## SUMMARY OF CONCERNS IN RELATION TO THE PROPOSED NORTHCONNEX TUNNEL

**This is an objection to many aspects of the proposed NorthConnex tunnel.**

## SECTION A: THE CONNECTIVITY OF NORTHCONNEX SOUTHERN VENTILATION FACILITY AT THE SOUTHERN INTERCHANGE, THE SOUTHBOUND TUNNEL IN PARTICULAR

Figure 5-17 Motorway operations complex

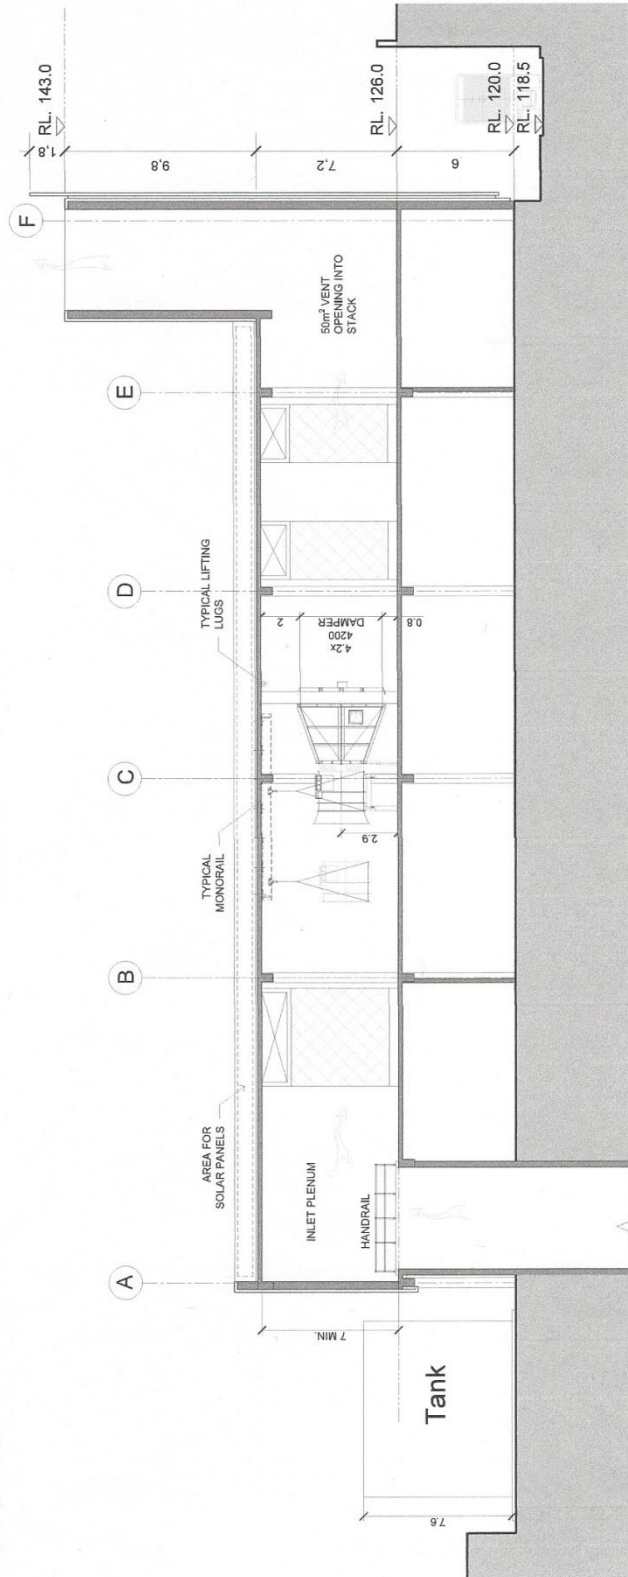
EIS Page 111, *Figure 5-17 Motorway operations complex*

*Page 8 below* there is no indication of how the ventilation facility will be connected to either the northbound or southbound tunnel, nor is there any indication of how the southbound exit portal onto Pennant Hills Road or the south-west exit portal onto the M2 will be connected.

In each of the above figures for Wilson Road, Trelawney Street, and Northern Ventilation facility, the shafts, emergency smoke extraction buildings, and ventilation facility make a substantial footprint in the construction area; however for the Southern Interchange the ventilation facility is an insignificant part of the construction area. How can this be? The difference in scale does not explain the difference.

We also find it disturbing that in each of the above figures for Wilson Road, Trelawney Street, and Northern Ventilation facility the headings are for “*tunnel support facility operational layout*” and “*ventilation facility operational layout*” but for the Southern Interchange the description is for “*Motorway operations complex*” with no mention of the ventilation facility or the tunnels.

- Diagrams need to be provided showing the inter-relation between the shaft, the ventilation outlet and the motorway operations centre with a clear description of what is to be constructed and how it will operate.
- The community needs irrefutable evidence that the polluted air from the southbound tunnel exit portals will not be allowed to flow like an invisible sewer through West Pennant Hills, North Rocks, Carlingford and Beecroft.

MOTORWAY OPERATIONS COMPLEX - SOUTHERN VENTILATION FACILITY - SECTIONS  
M1-M2-5000-DR-JD-0525

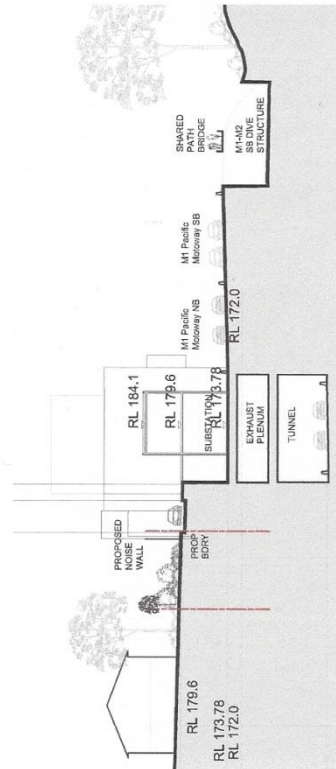
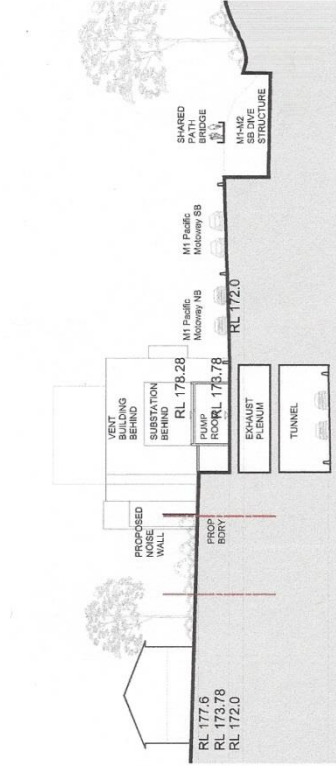
5. *EIS Volume 4, Technical working papers - Urban Design, 6.0 Operational Ancillary Facilities*  
EIS Page 99 there is the diagram "Motorway Operations Complex – Southern Ventilation Facility – sections. *Page 10 below* The diagram has the cryptic label "Connection to tunnel TBC". What does TBC stand for? To be considered? Why is tunnel singular? Which tunnel is the diagram referring to northbound or southbound? There is no diagram showing any connection from the Southern Interchange ventilation facility to either the northbound or the southbound tunnel in any way AND YET ....
